3.24 LEGIBILITY OF PUBLIC OPEN SPACE AND SITE LINKAGES

3.25 PUBLIC/PRIVATE SPACES MEASURED PLAN

3.27 LEGIBILITY OF PUBLIC OPEN SPACE AND SITE LINKAGES

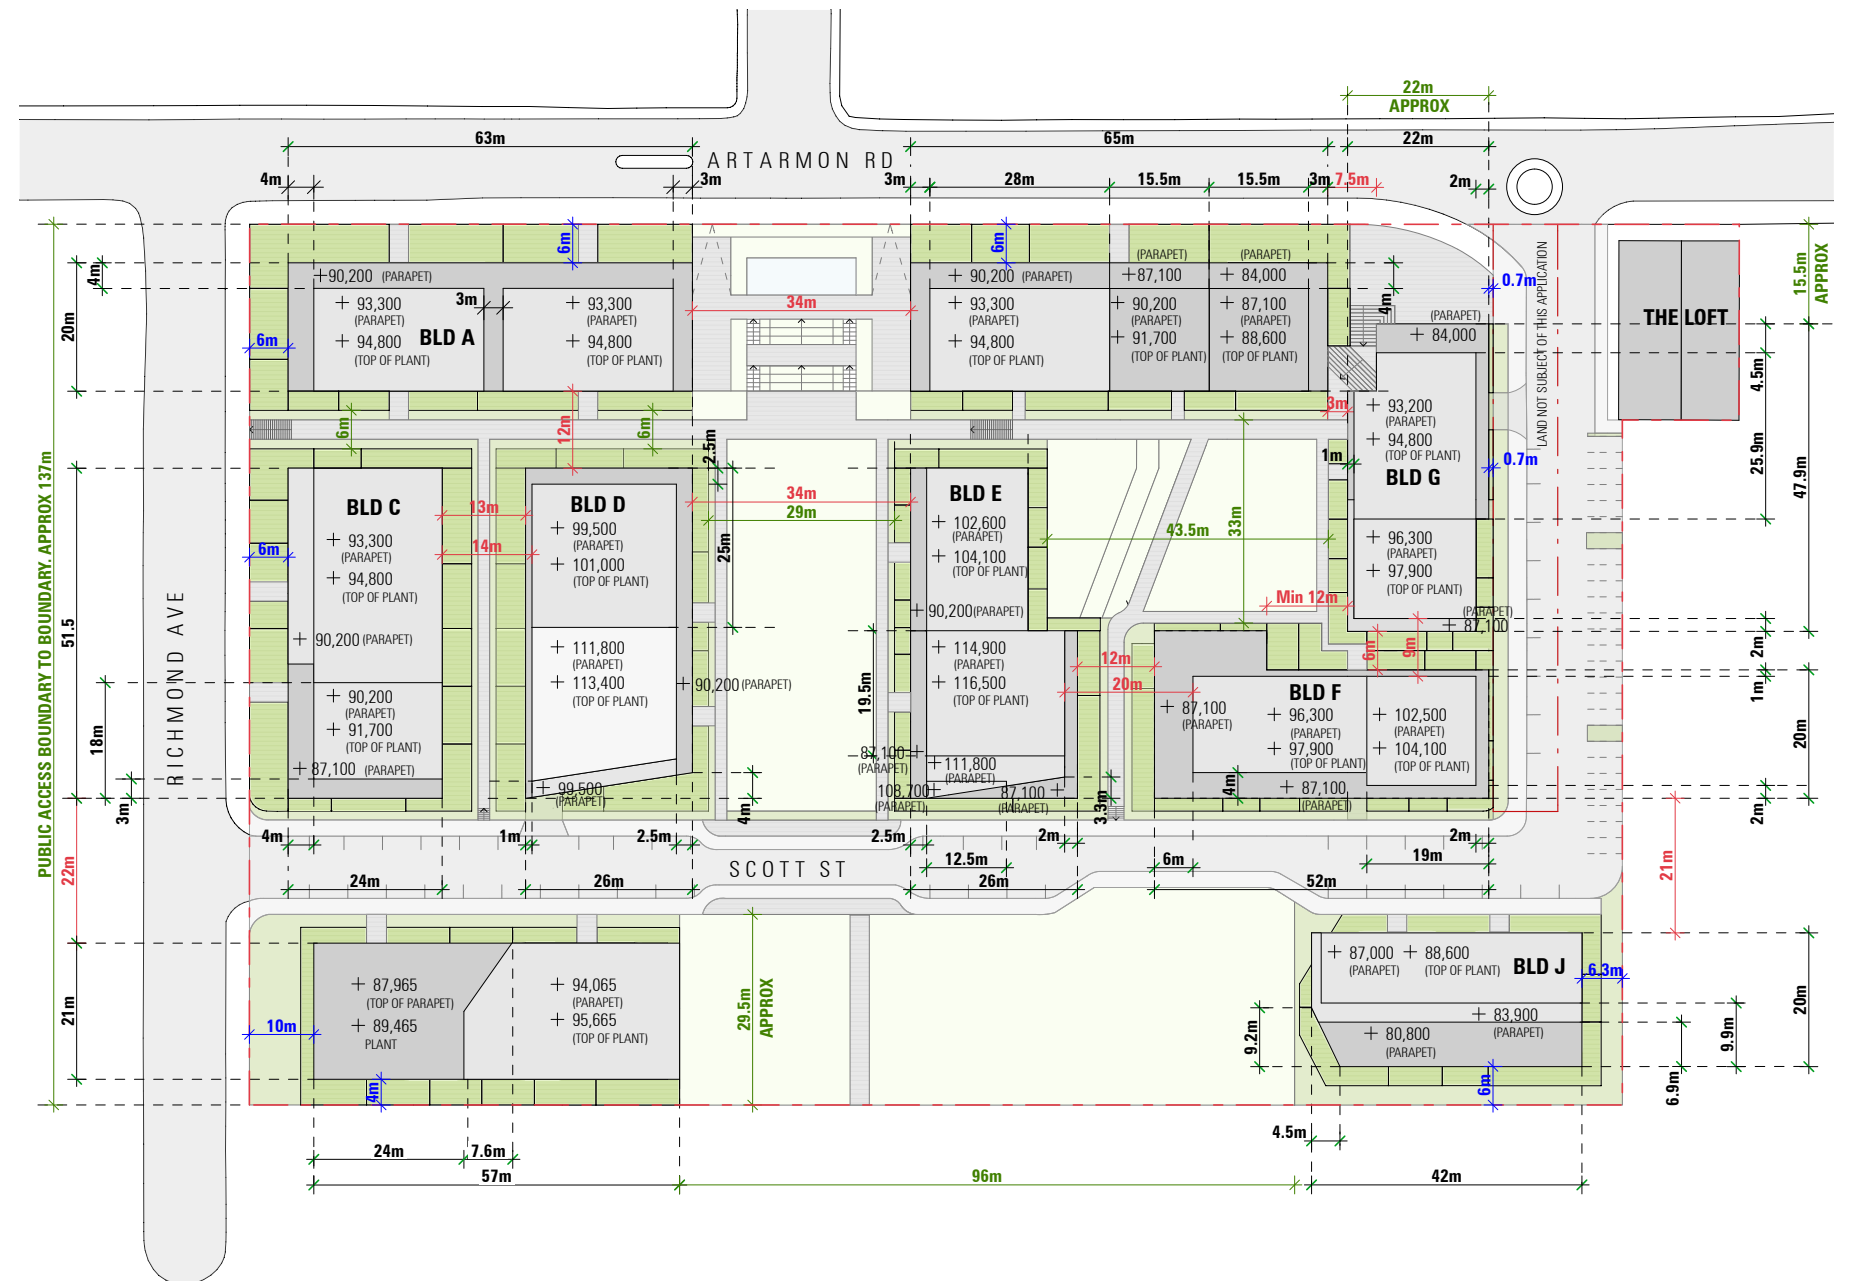
The AJ+C Concept plan review recommended a tightening of the Gateway by increasing building A and B. We have only tightened the gateway so that all buildings A/D and B/E align across the Village Green. The generous width of the Village Green and Gateway are considered vital to create an inviting public park, and as such have been largely maintained in this design.

Measured plans with the public space dimensions have been provided in the updated Appendix1_Rev1 Architectural Drawings.

The wide Gateway helps create a strong view connection between Edward Street and the southern views. It also ensures the park is visible and accessible for the wider community.

CURRENT MODIFICATION 2 -
DRIVEWAY LOCATED ON SCOTT
ST, PUBLIC THROUGH SITE
LINKS STRENGTHENED

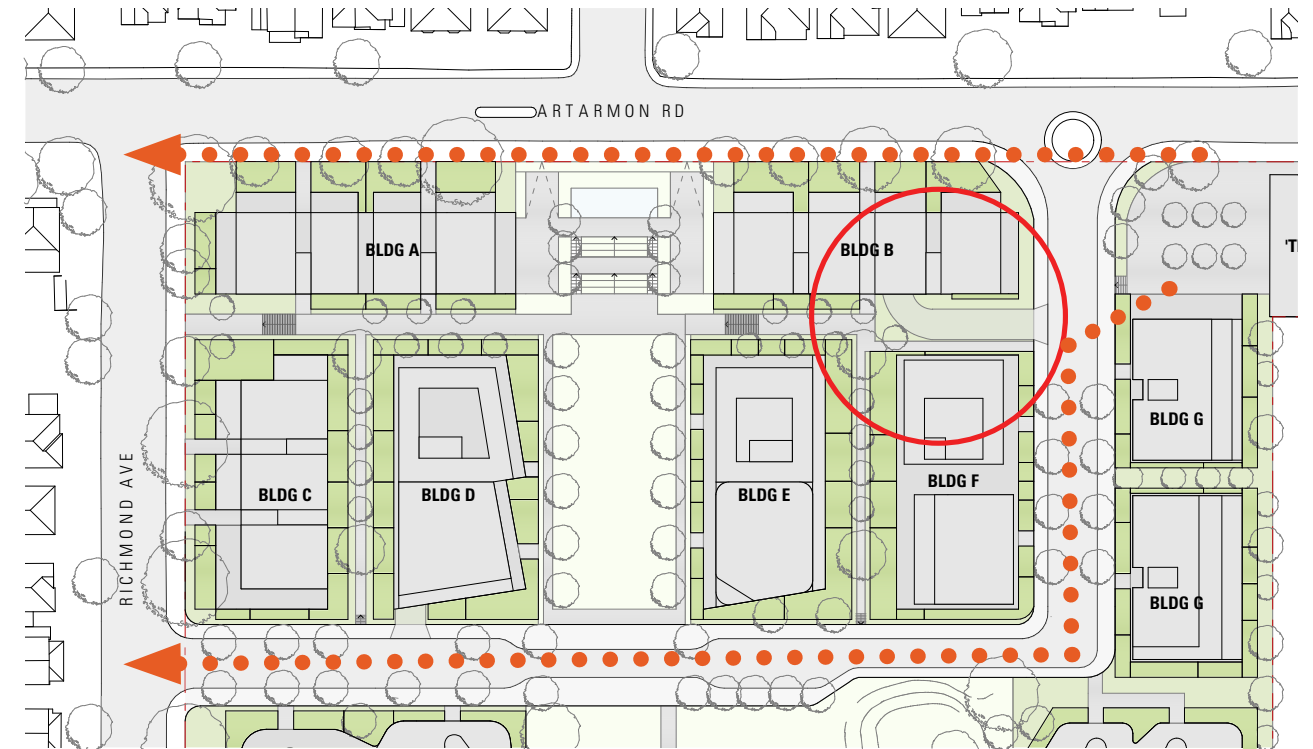
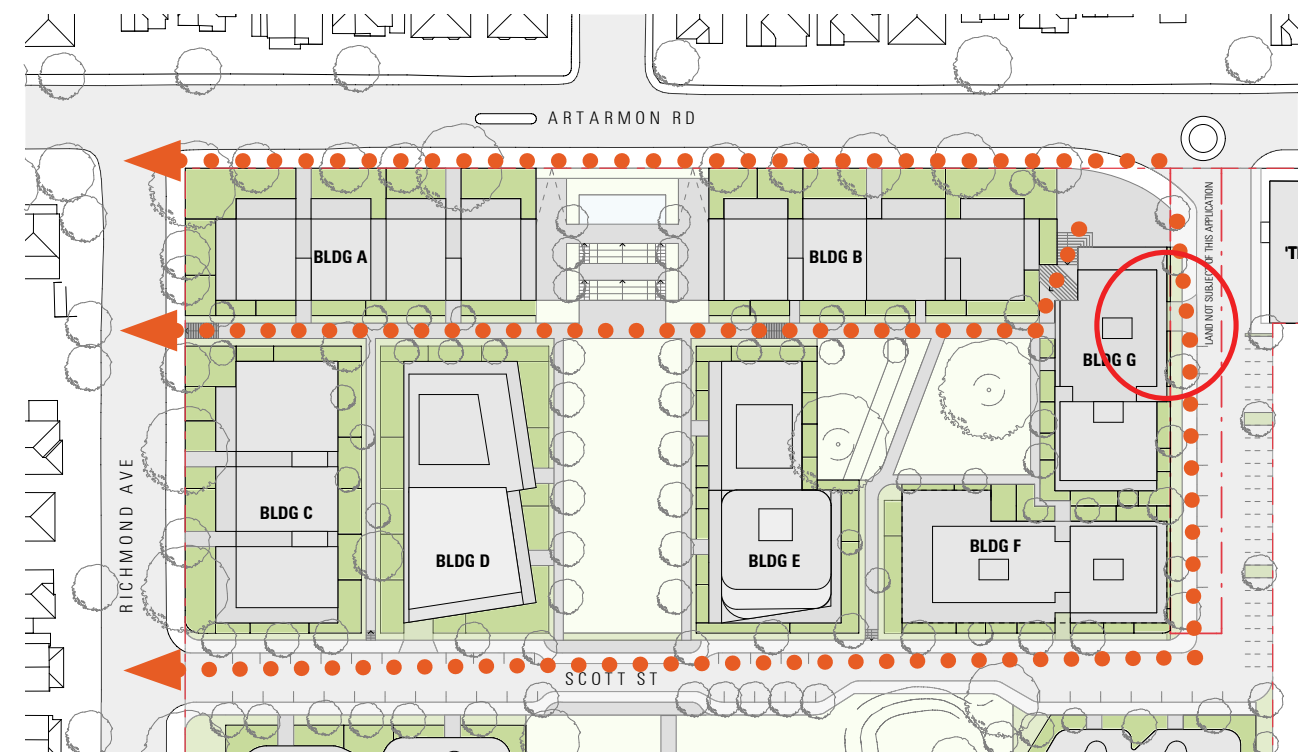
In response to design suggestions by AJ+C for better site linkages between the Village Square and the Gateway, the following changes have been adopted since modification 1 to improve through site connections and provide a stronger link between the Village Square and the Gateway.

- The driveway originally proposed between building B and F has been relocated into building G.
- The retention of Scott St in its original location and the relocation of the Village Square has allowed for a new generous public stair which creates an inviting pedestrian link with clear site lines up to tree 32 and the Village Green beyond.
- The through site public link is now possible from the Village Square to Richmond Ave both along Artarmon Rd and through the new courtyard pedestrian link.
- The through site link is proposed to include a 3m wide footpath, with 1.5m of public open space for planting on either side of the path. This is a total of 6m for the public through link.
- A generous public square creates an inviting pedestrian link with clear site lines up from the Village Square, to tree 32 and the Village Green beyond.

MODIFICATION 1 - DRIVEWAY
LOCATION BETWEEN
BUILDINGS REDUCING THE
THROUGH SITE LINK

3.31 A NEW COURTYARD FOR TREE 32

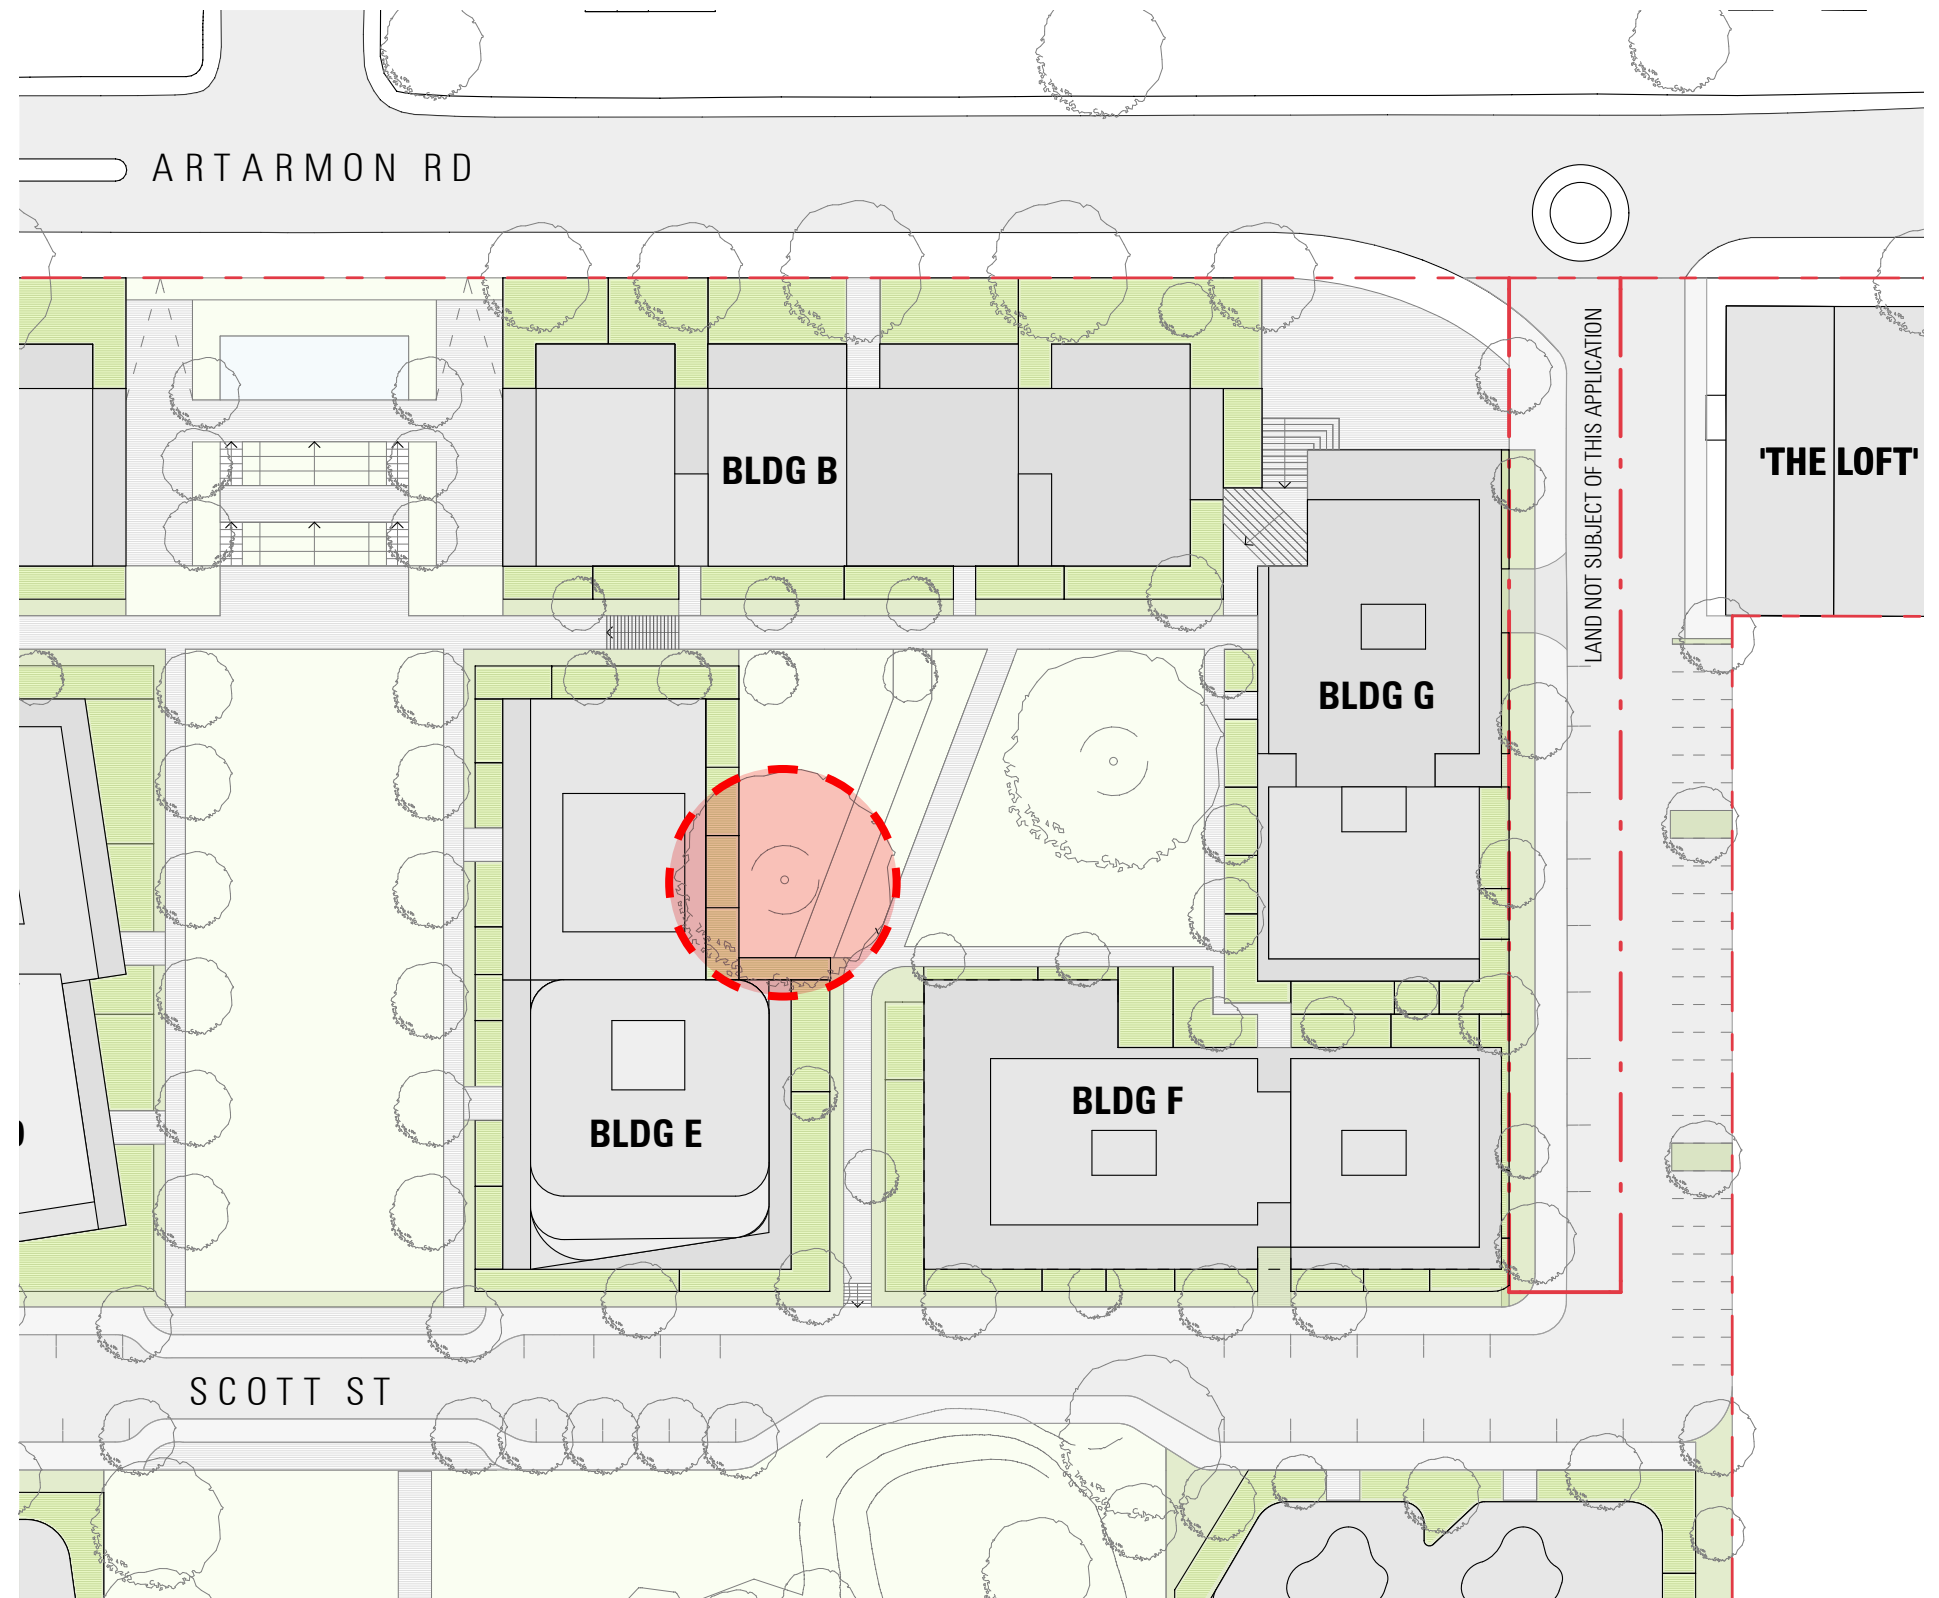
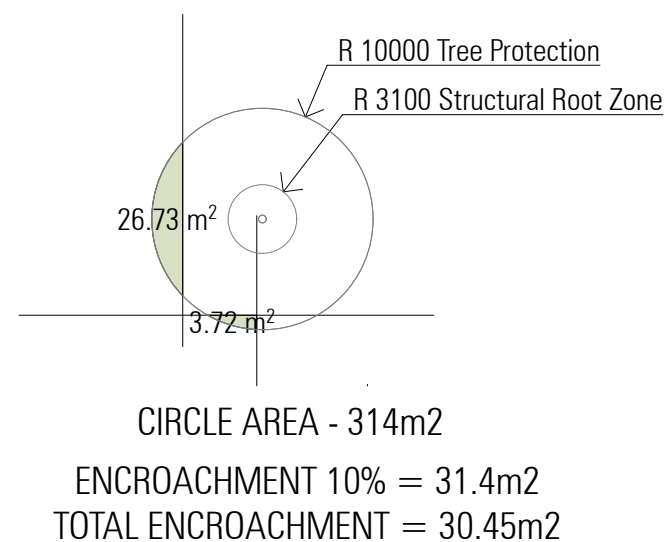
In line with the AJ+C suggestions to retain the tree, the building form has been altered to allow for tree retention including a 10m tree protection radius, and a 3.1m structural route protection zone.

The base RL of tree #32 is RL 77.91, requiring the central courtyard to be split in level.

The building envelope form encroaches to a maximum of 10% area of the tree protection 10m radius from the center of the tree, as seen in the diagram below.

Elevational photo of Artarmon Rd, looking north at the current Scott St location, demonstrating the raised level of existing houses with a stone wall on the street.

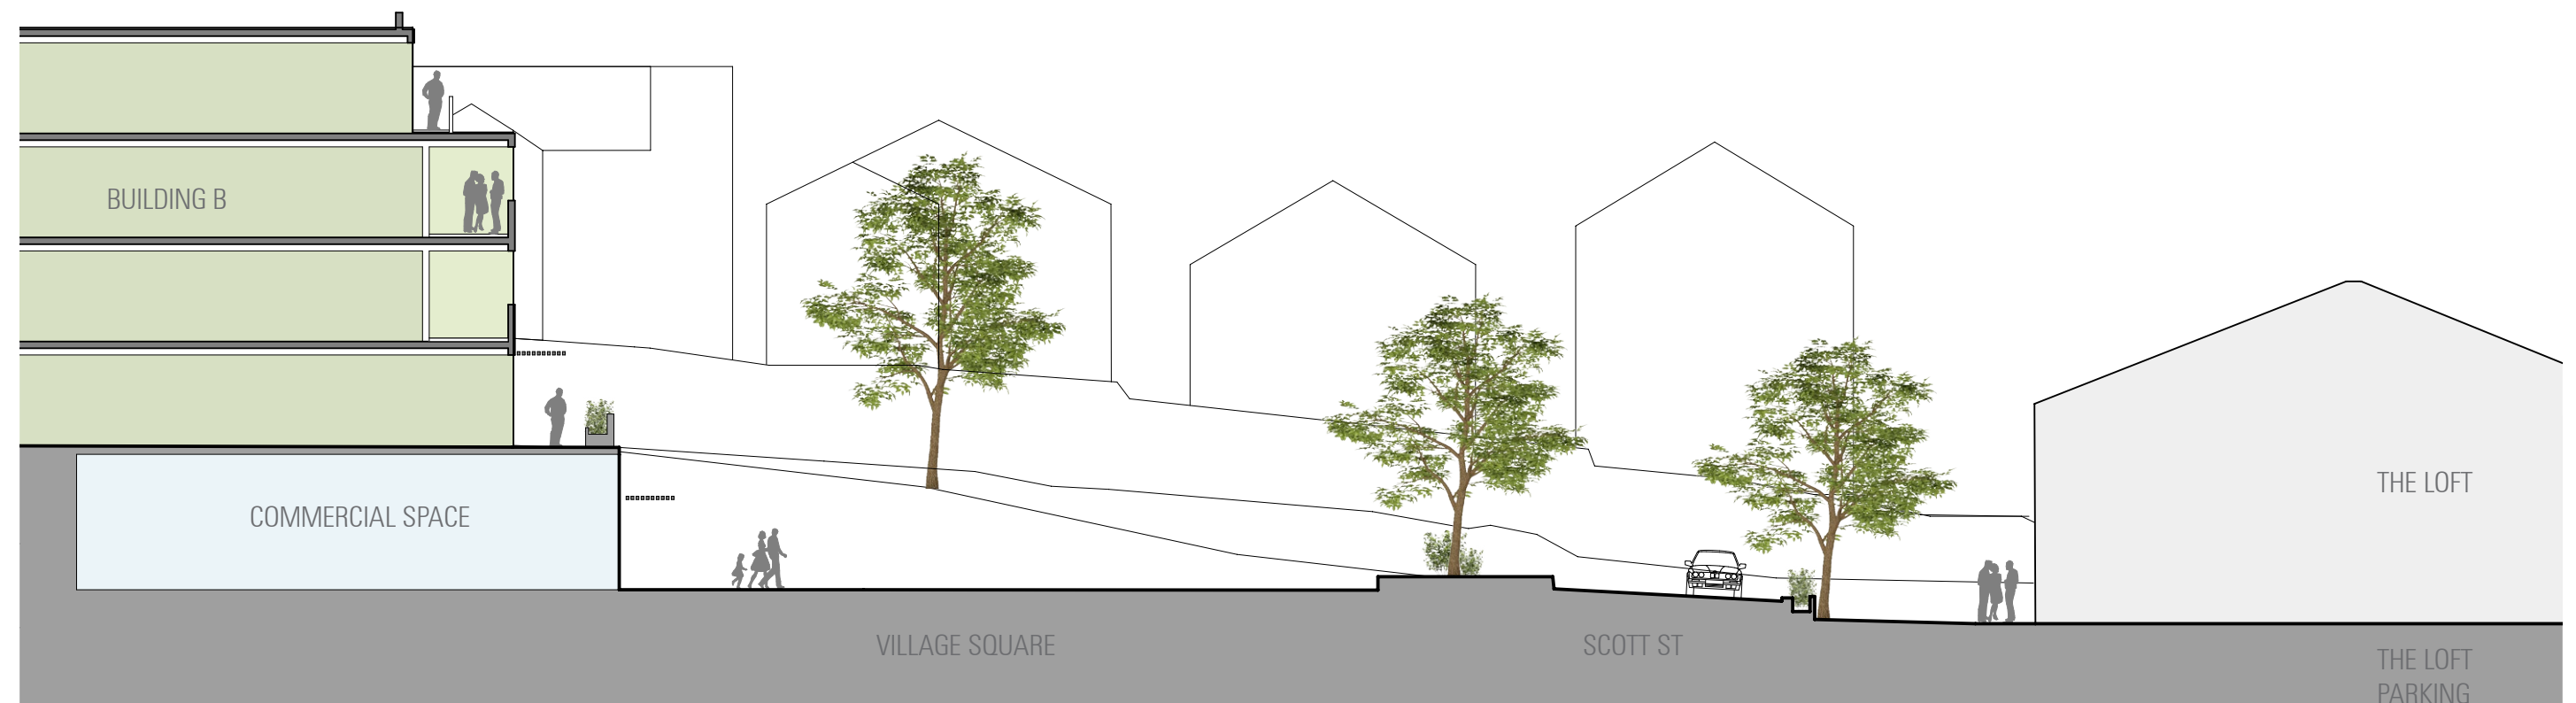
The Council Concept Plan review by AJ+C noted concern with privacy for units on the ground level of building B.

We note that with the design changes, this concern for the ground level of building B may no longer be current.

The following section demonstrates the new relationship between the Village Square and building B. The proposed plan has sufficient space for a private courtyard, privacy planting or screen and footpath. The steep nature of Artarmon Rd along with the escarpment on the other side of the road creates some significant level changes, which can be explored to enhance privacy and reduce overlooking.

The apartment level, raised a full level above Village Square, will help to mitigate overlooking issues from the Village Square, will help separate the public realm from the private buildings.
